Integrus Architecture, P.S.
117 S Main Street
Seattle, WA 98104
(206) 628-3137

The additions, clarifications and corrections contained herein shall be made to the Project Manual, Drawings and Schedules for the above referenced project, and shall be included in the scope of work and proposal to be submitted.

Sartori Elementary School

CLASSROOM 204 - EAST

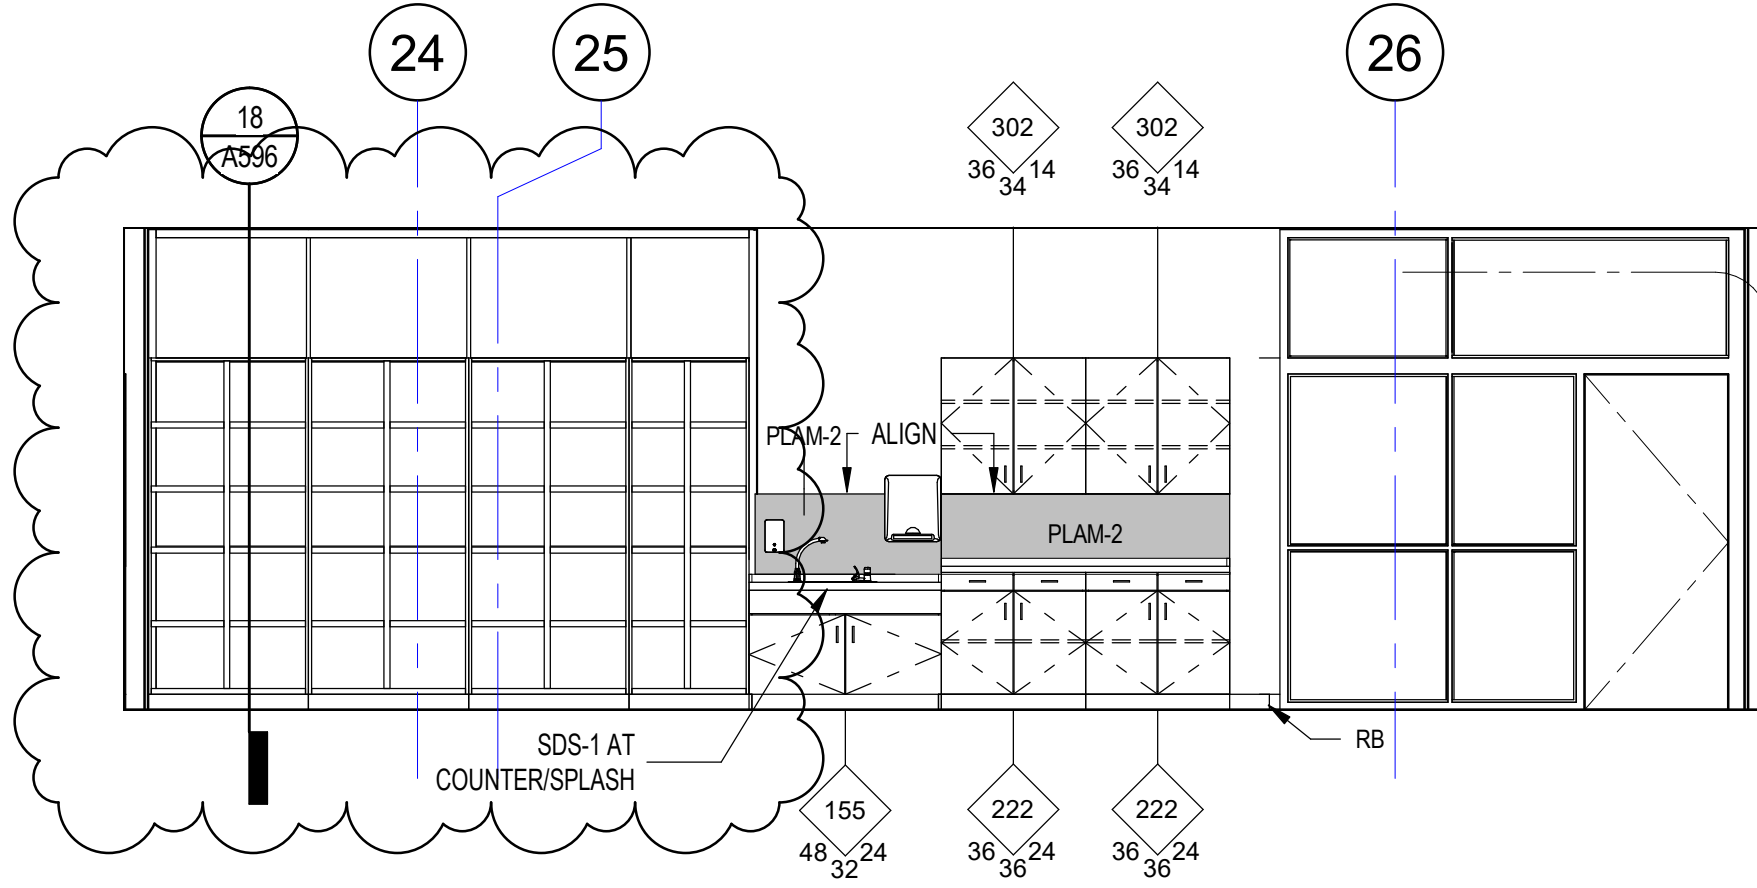
- Item #A10 A733 – INTERIOR ELEVATIONS LEARNING SPACES
ADD #03 **Revise** CLASSROOM 204 – EAST to reflect updated makerspace cubby spacing and extents per attached ADA-077.
